BAKERS HOUSE

25 Bakers Road, Uxbridge, UB81JY

15th November 2019

This Addendum Design Statement describes in detail all the architectural changes made.

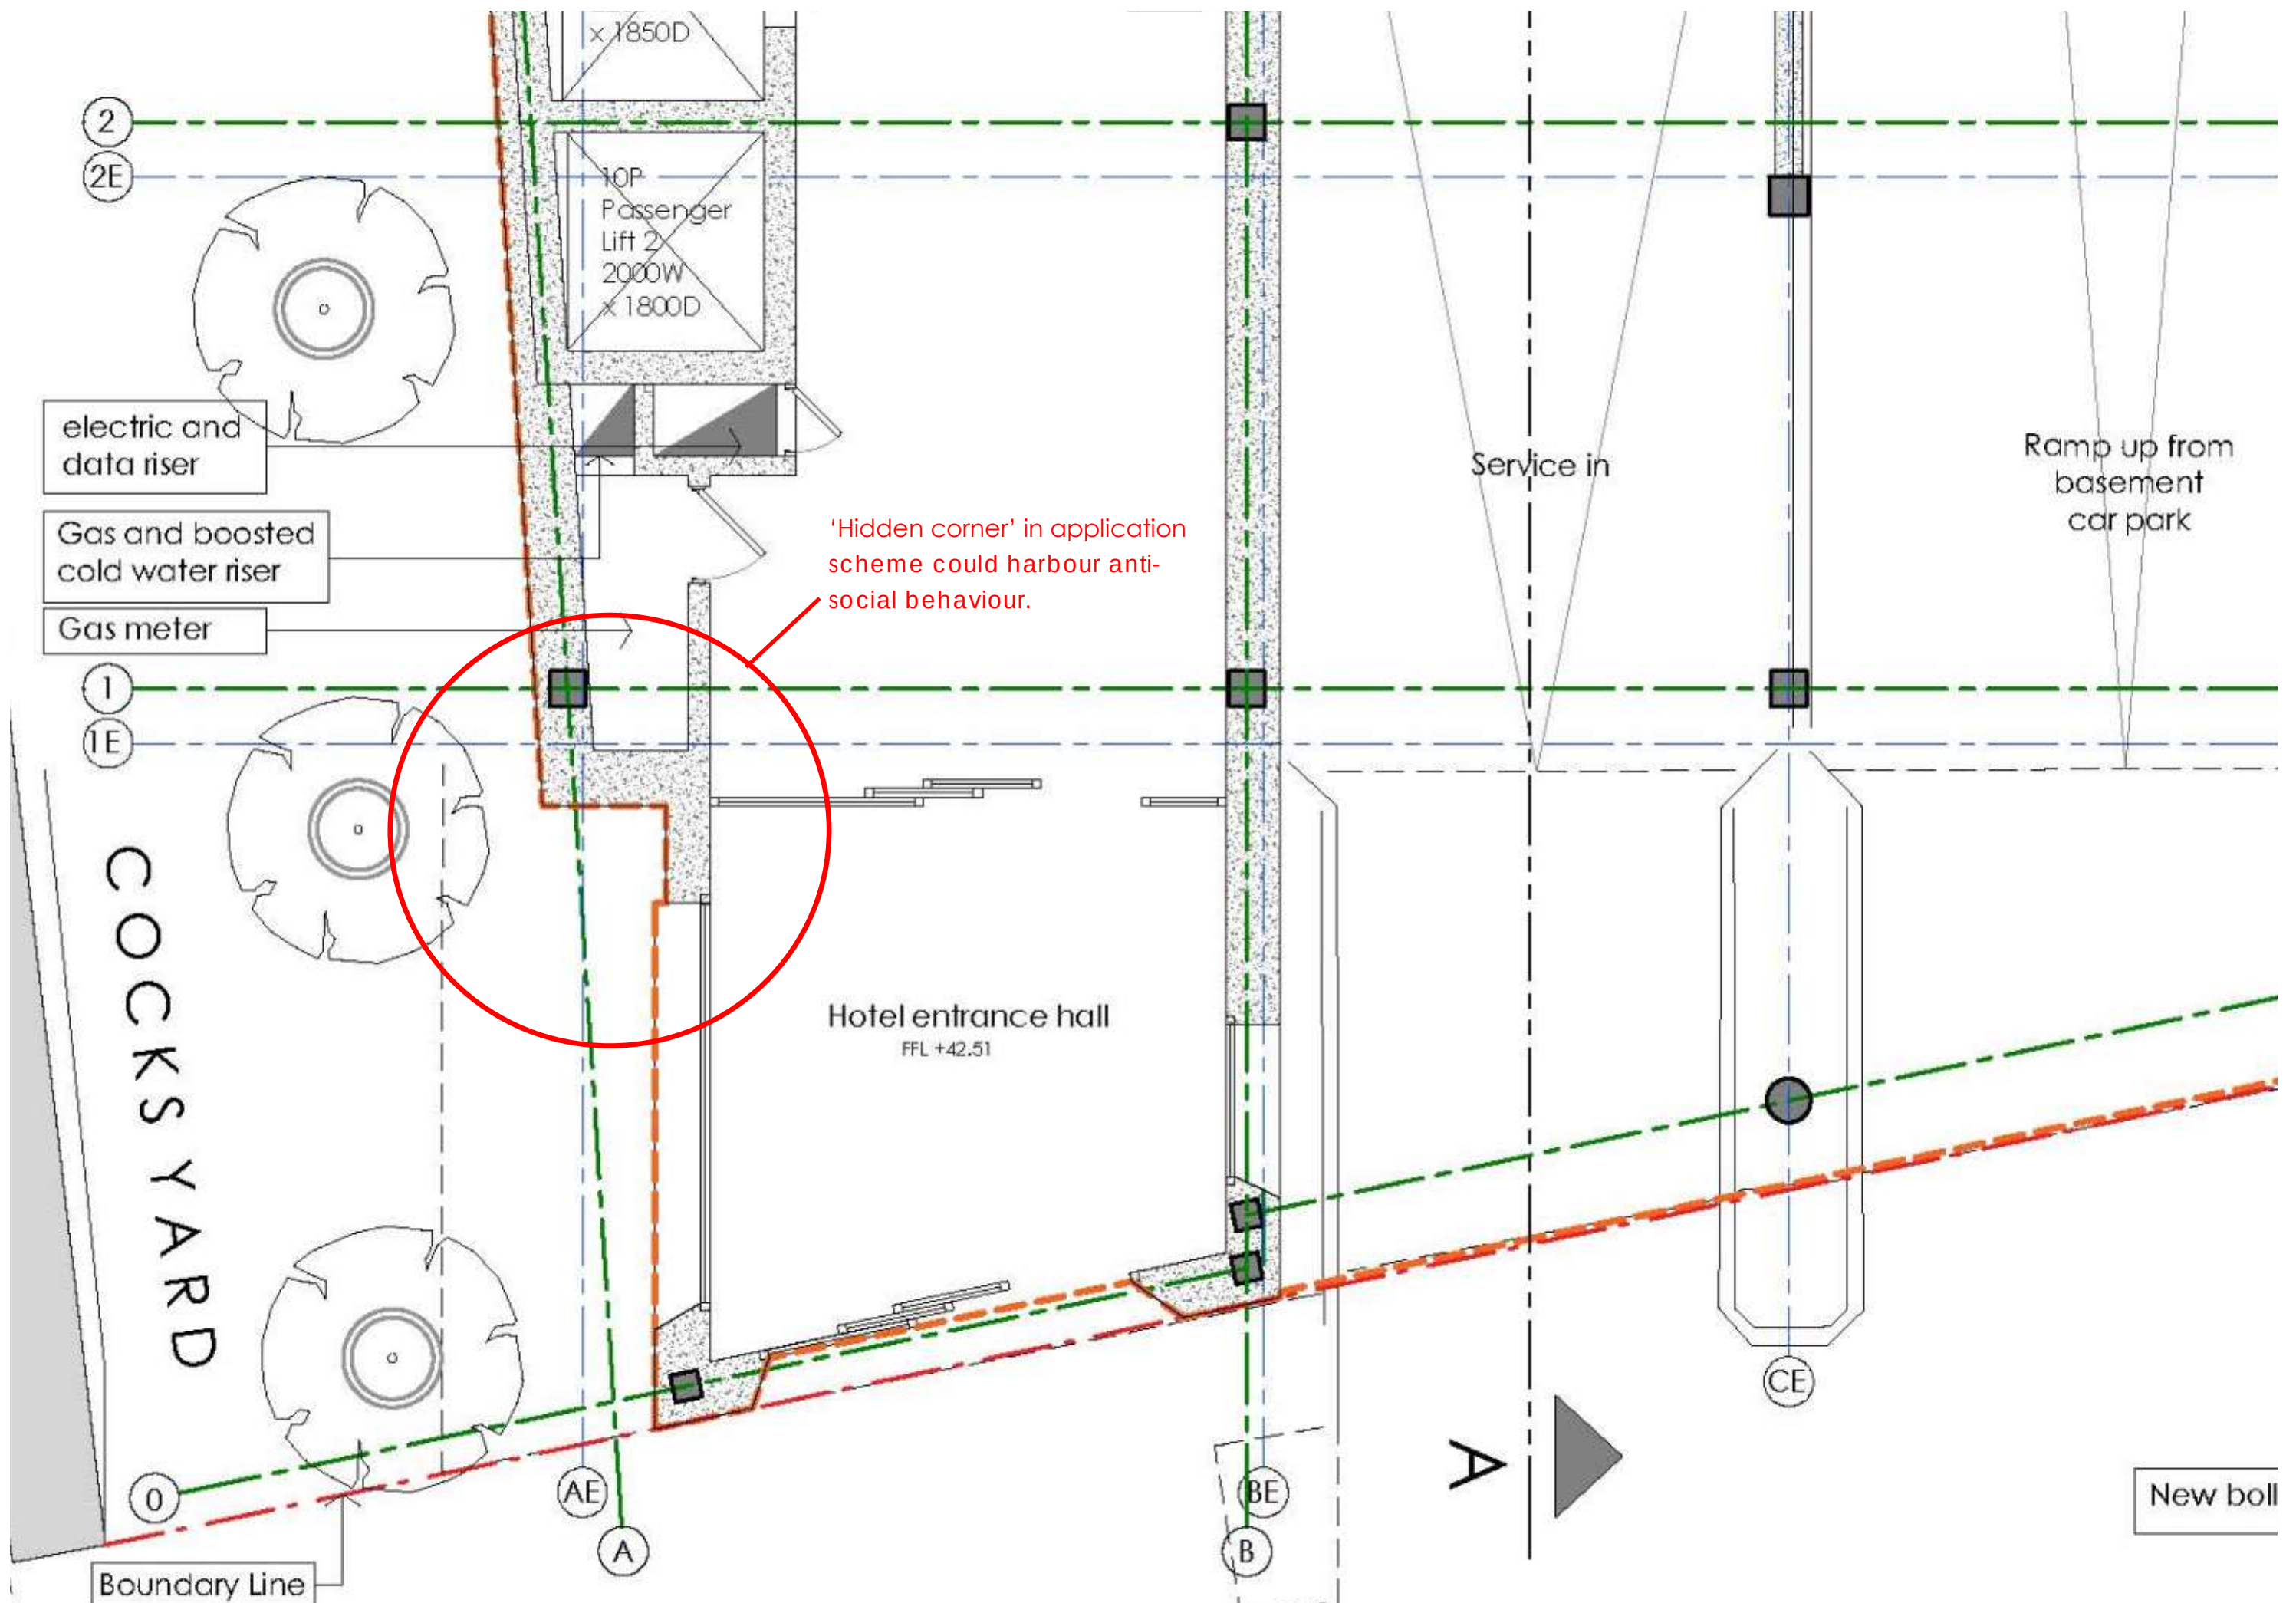
At ground floor level in the original application, Cocks Yard was mostly faced up with a solid brick wall and an escape door from the internal fire staircase. The revised scheme introduces more transparency by extending a wide staircase window down to ground floor level. Further fenestration at ground floor is difficult, but the ground floor is not tall, and bedroom windows from first to seventh floors (incl.) provide the necessary vitality and surveillance needed over this part of the pedestrian link.

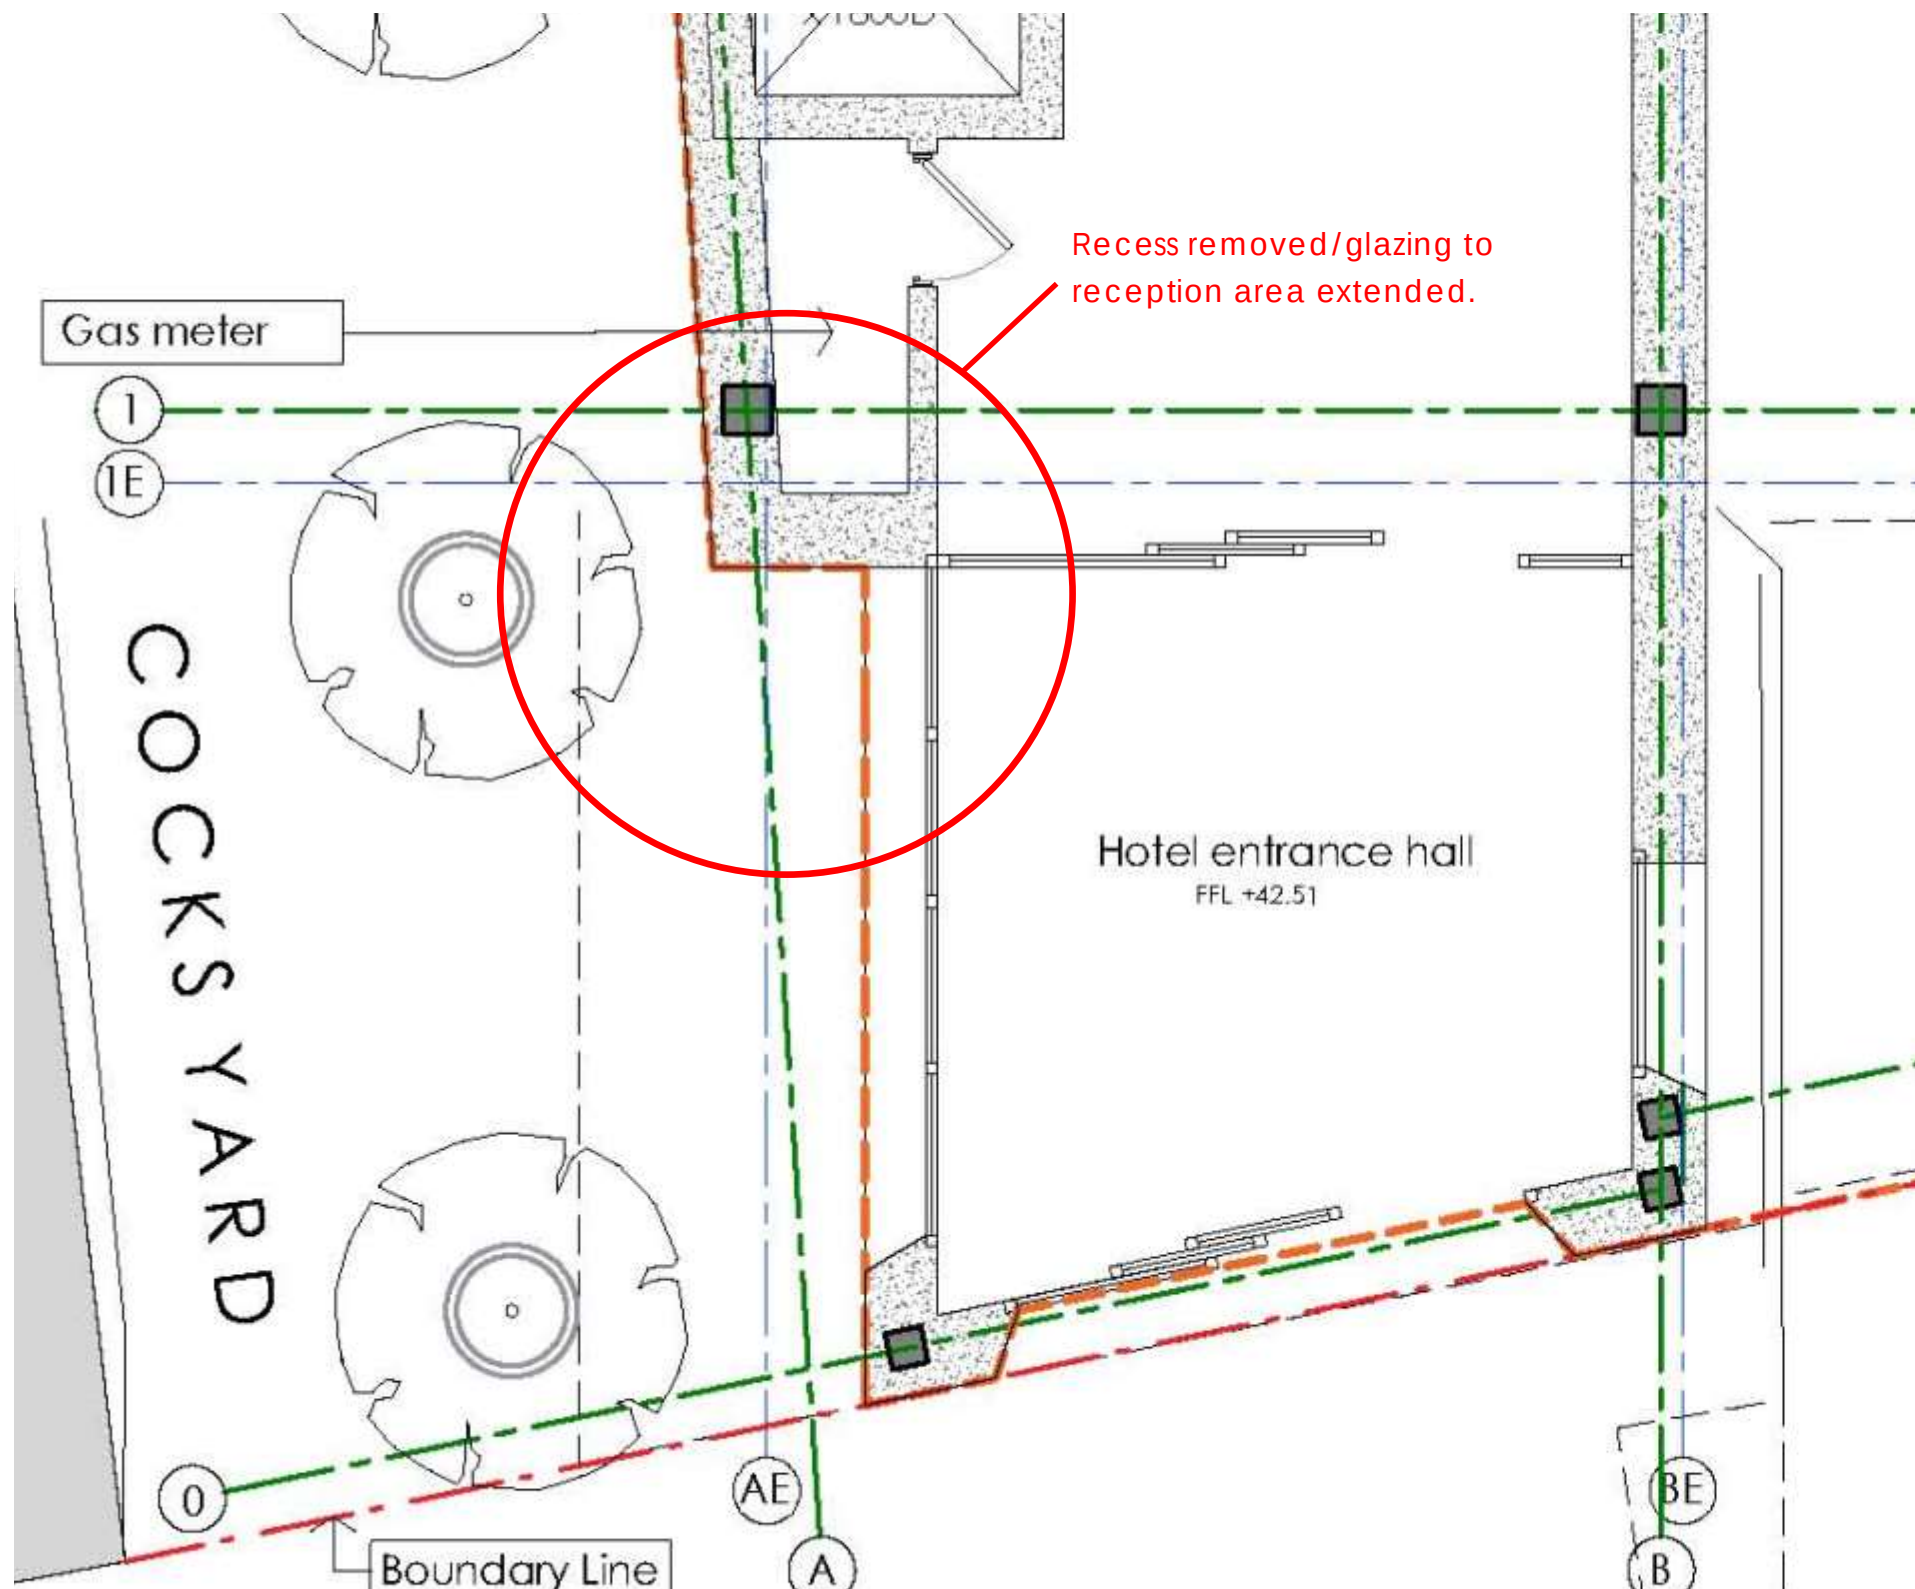
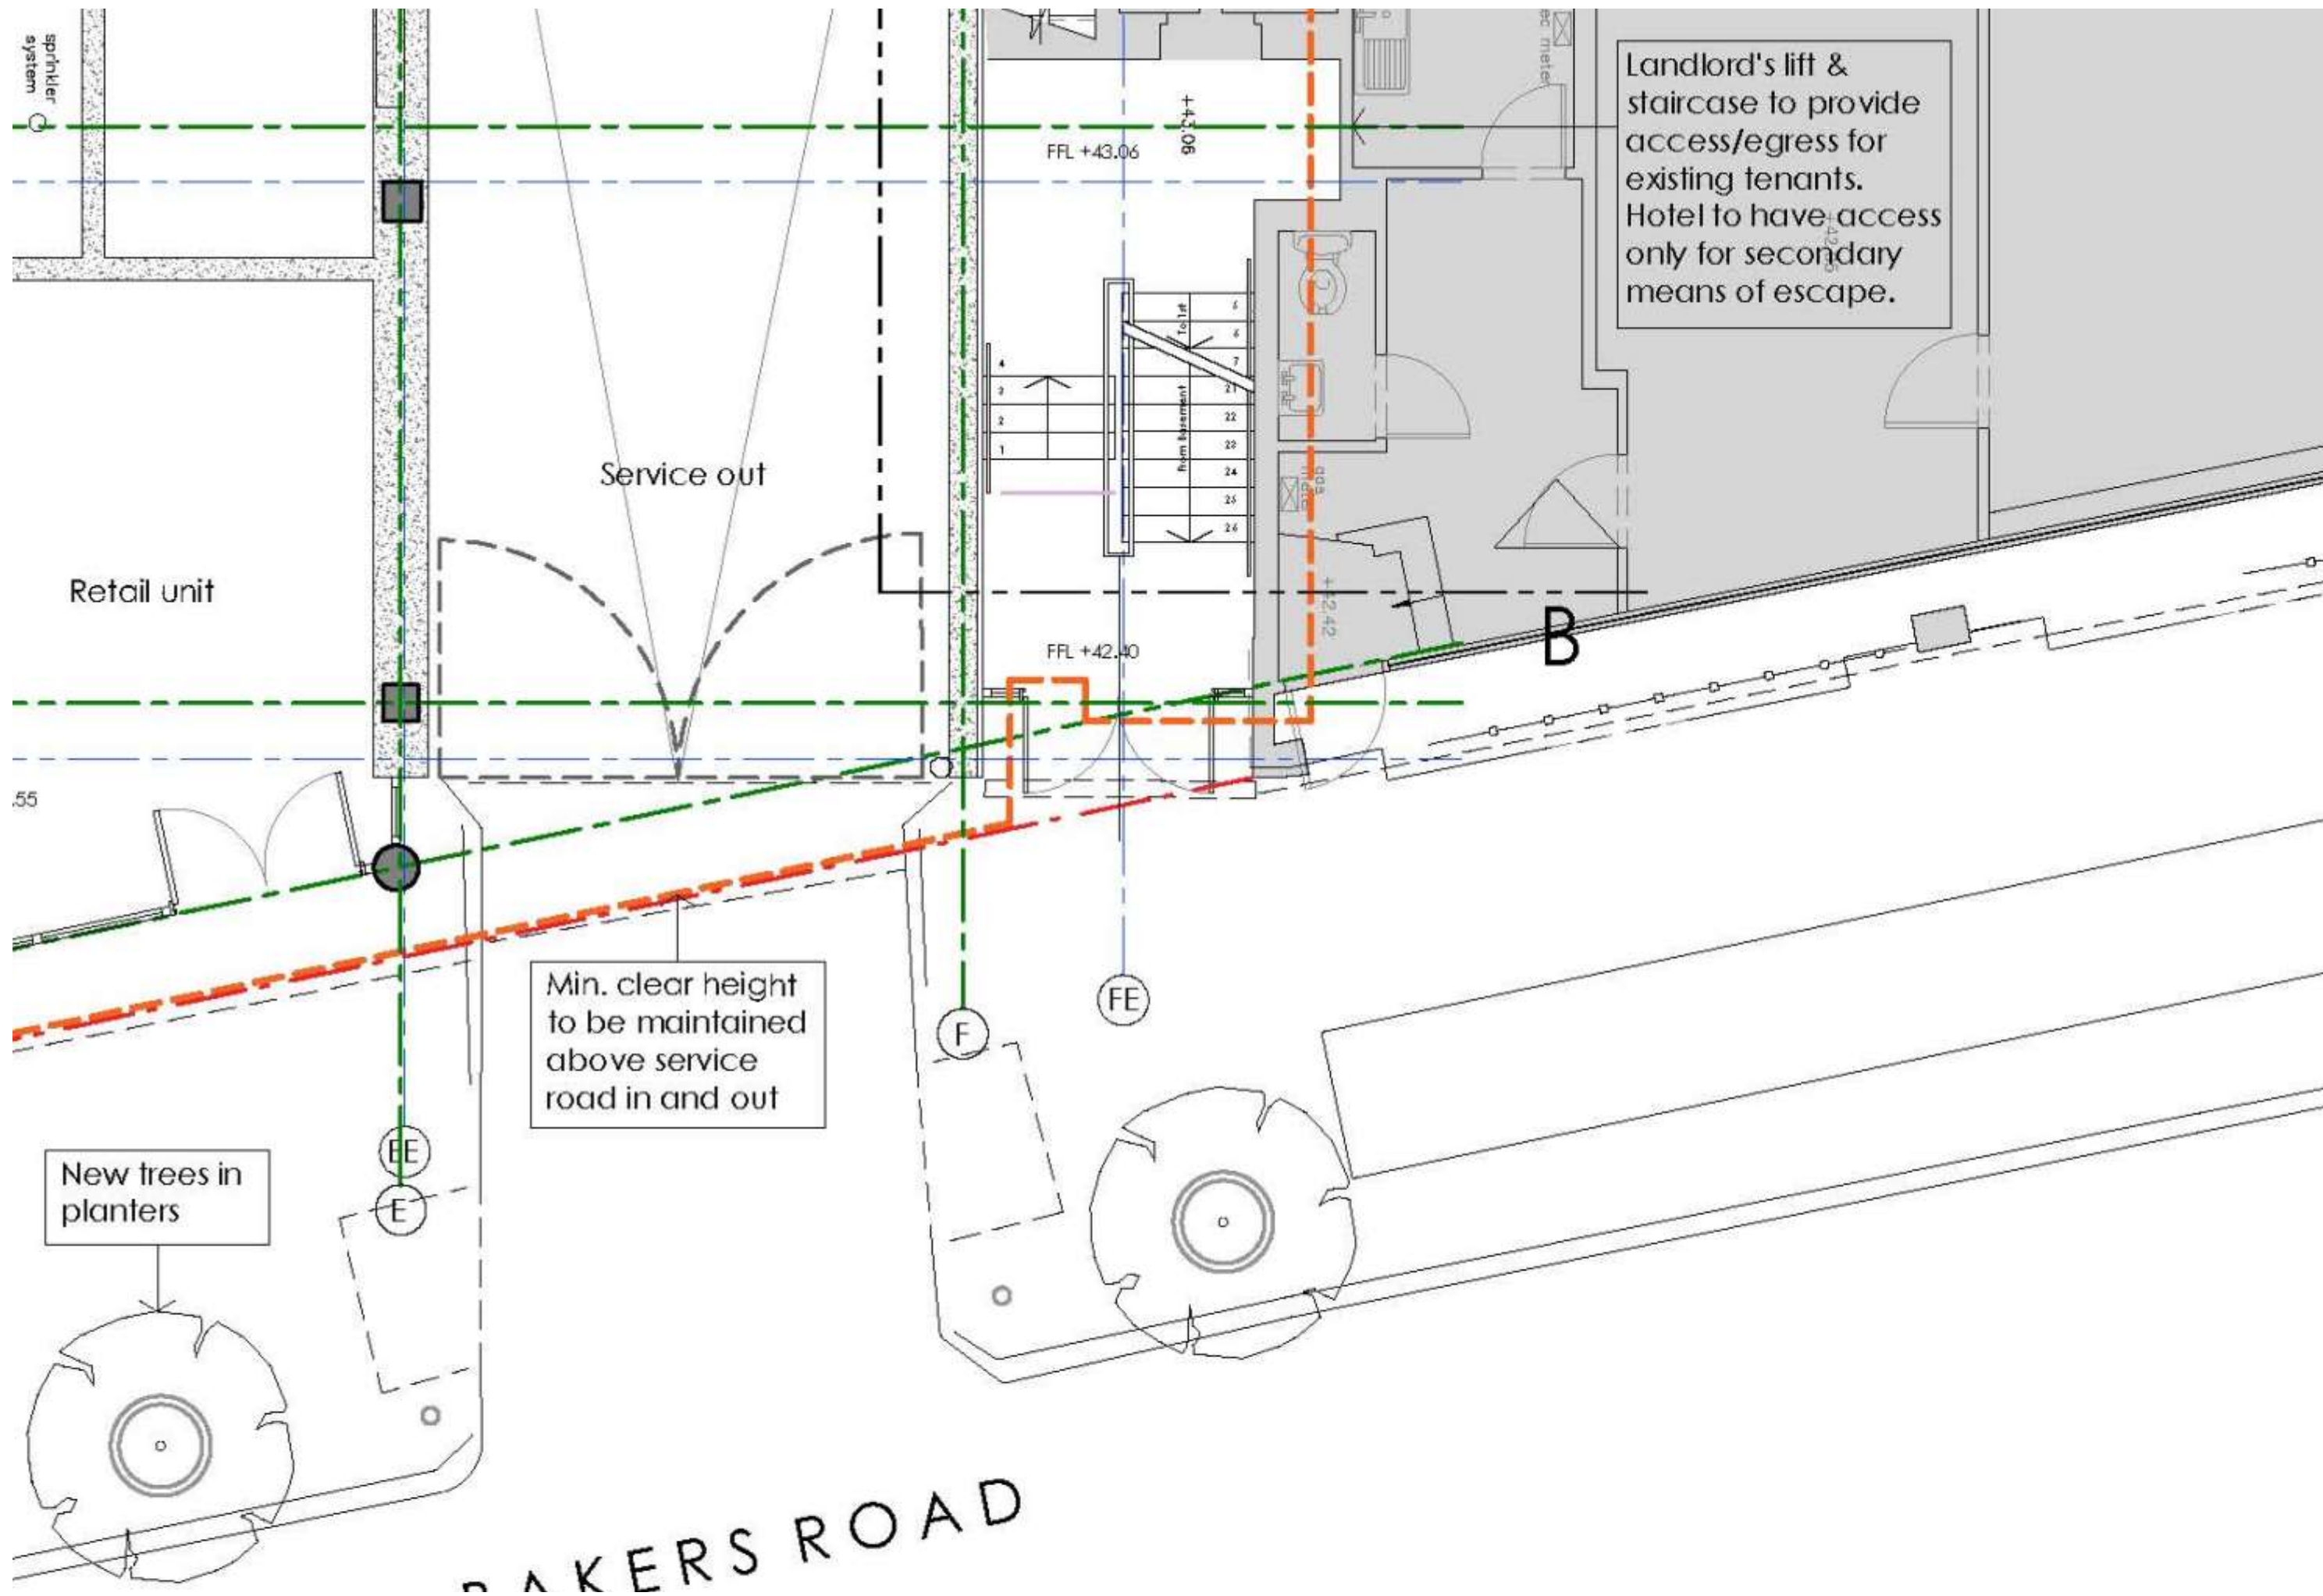
Concerns have been expressed that at the northern end of Cocks Yard, the original application scheme introduced a 'hidden' corner where anti-social behaviour might prevail. Our revised scheme overcomes this by enlarging the proposed glazing onto the hotel reception area at this point.
